**TOWN OF LOS GATOS
PLANNING COMMISSION
REPORT**

DATE: August 19, 2022
TO: Planning Commission
FROM: Joel Paulson, Community Development Director
SUBJECT: Review and Recommendation of the Draft Objective Standards to the Town Council.

TOWN OF LOS GATOS
DRAFT OBJECTIVE STANDARDS
August 24, 2022

Summary of Revisions Made and Responses to Comments Received at the Planning Commission Hearing of June 22, 2022

Figure A.11.1

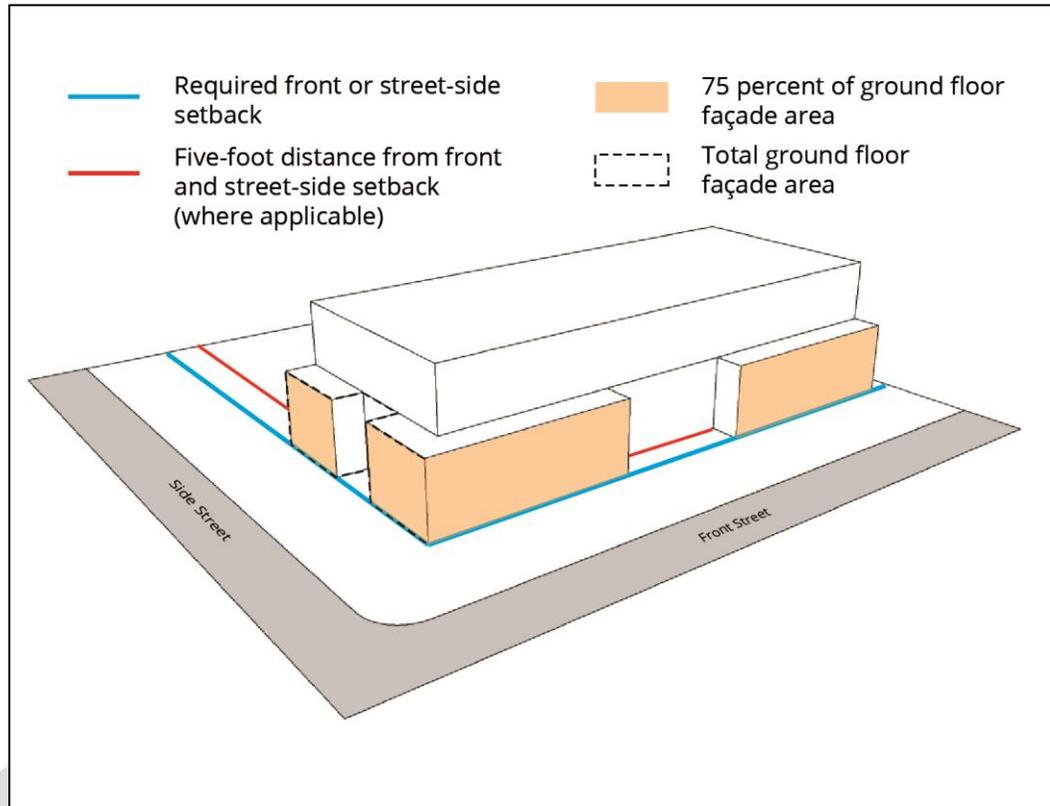
New A.11.1 (Line 41): The Community Design Element of the 2040 General Plan encourages consistent setbacks Town-wide and reduced setbacks in Community Growth Districts (CGD). For this reason, Standard A.11.1 was written to be specific to CGDs. Given the polices in the Community Design Element and the comments made by the Planning Commission during discussion of this item, staff requests direction on whether this standard should apply Town-wide or only within CGDs.

41	A.10.1	A.11.1	Why does this only include Community Growth Districts (CGDs)?	<p>The following polices discussing setbacks are included in the Community Design Element of the 2040 General Plan:</p> <p>CD-2.10 (Town-wide): Well-Defined Street Fronts - Require new buildings to maintain a consistent setback from the public right-of-way in order to create a well-defined streetscape. Require new buildings throughout Town to use consistent setbacks.</p> <p>CD-7.1 (All CGDs): Neighborhood-Friendly Design - Encourage buildings and sites within all Community Growth Districts regardless of designation, including shopping centers undergoing redevelopment, to integrate design features that create a pedestrian- and neighborhood-friendly environment, such as by siting buildings close to the sidewalks, providing space for small plazas, and including public art.</p> <p>CD-9.1: (LGB CGD): Setbacks and Step Backs of Massing - Require medium density, high density, and mixed-use parcels in the Los Gatos Boulevard District adjacent to single-family parcels to include increased site setbacks and multi-story step backs to minimize the impact and increase compatibility with smaller adjacent structures.</p> <p>CDP-11.7: (Lark CGD): Reduced Setbacks - Allow reduced setbacks to foster a more urban environment focused on corporate centers, commercial shopping areas, medical services, and hospitality uses.</p> <p>Consistent setbacks are encouraged by CD-2.10, while reduced setbacks are encouraged in CGDs. For this reason, Standard A.11.1 was written specific to CGDs. Given the above polices and the comments made by the Commission during discussion of this item, staff requests direction on whether this standard should apply Town-wide or only within CGDs. The corresponding figure/diagram will be updated accordingly.</p>

Likes that it only applies to Community Growth Districts otherwise it could make them look out of place. It might also limit design related to arcade setback standards in Section B.	
			Can we apply this just to mixed-use? It should apply to ground-floor commercial.	
			Big focus during GP discussions was street-activation and should be kept in mind during revisions.	
41	A.10.1	A.11.1	Perhaps replace "Community Growth District" with "Mixed-Use".	
42	B.1.1	B.1.1	There is chance that using three of these approaches may result in poor design. Maybe two would be better. Perhaps anchor it to the amount of street facing façade that exists. If under 50 feet, only require two.	This Standards continues to require implementation of at least three solutions. Staff evaluated several projects in the Town to see if they would meet this Standards (Exhibit X). A quality design should not have a problem implementing at least three solutions.

Figure B.4.1f

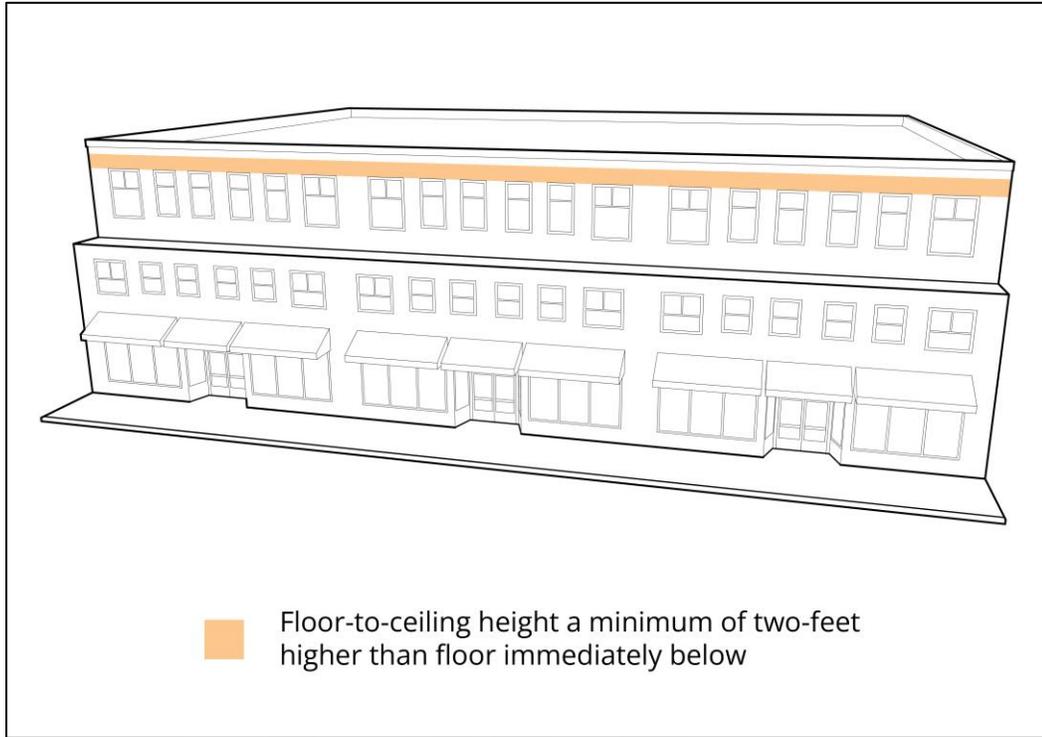
48	B.3.1.c	B.3.1.c	Staff addition/revision.	Revised the change in façade or roof height from four feet to two feet to align with the height limitations of the Town Code.
49	B.3.4	B.3.4	Staff addition/revision.	Deleted to eliminate potential conflict with architectural styles.
50	B.4.1	B.4.1	Example pictures would be helpful.	Photographic examples of the concepts have the potential to communicate unintended values or design guidance. Diagrams have been updated throughout the document to better illustrate the concepts in a more realistic style. Staff does not recommend the use of photos in the document.
51	B.4.1.a	B.4.1.a	Staff addition/revision.	Revised the minimum percent from 70 to 60 percent following case study of buildings with similar heights to those allowed in the Town.
52	B.4.1	B.4.1	Why not include varied plate heights in this section? It would make for dynamic architecture.	Added B.4.1.f, offering a solution that the upper floor utilize a higher floor-to-ceiling height that is a minimum of two feet greater than the floor-to-ceiling height of the floor immediately below. New figure B.2.1.f added.
